BRIEFING: MD 190 NEEDS ANALYSIS

Maryland State Highway Administration (MDSHA) completed the MD 190 Needs Analysis for River Road / MD 190 between Springfield Drive and Little Falls Parkway within the Westbard neighborhood of western Montgomery County. The document outlines short-, mid-, and long-term improvements for the corridor by identifying strategies to address pedestrian and bicycle network deficiencies, enhance multimodal safety and improve travel conditions along the corridor.

Planning Staff recommend that the Planning Board transmit the following comments to the Maryland State Highway Administrative (SHA):

Figure 2: Long-term Conceptual Cross-section

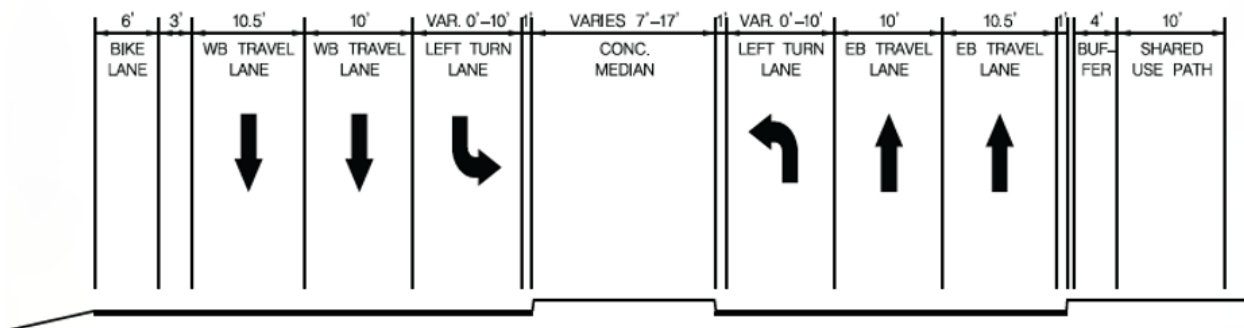
As currently shown in the Needs Analysis document, the proposed shared use path facility on the south side (eastbound direction) of MD 190 (River Road) ends to provide space for three travel lanes (two through-lanes and one left-turn lane). **In the long-term, further explore how to extend the eastbound shared use path on the south side (eastbound direction) of MD 190 (River Road) between Butler Road and Little Falls Parkway.** The 2018 *Bicycle Master Plan* identifies this facility connecting to Little Falls Parkway. The long-term improvement should be consistent with the *Bicycle Master Plan*.
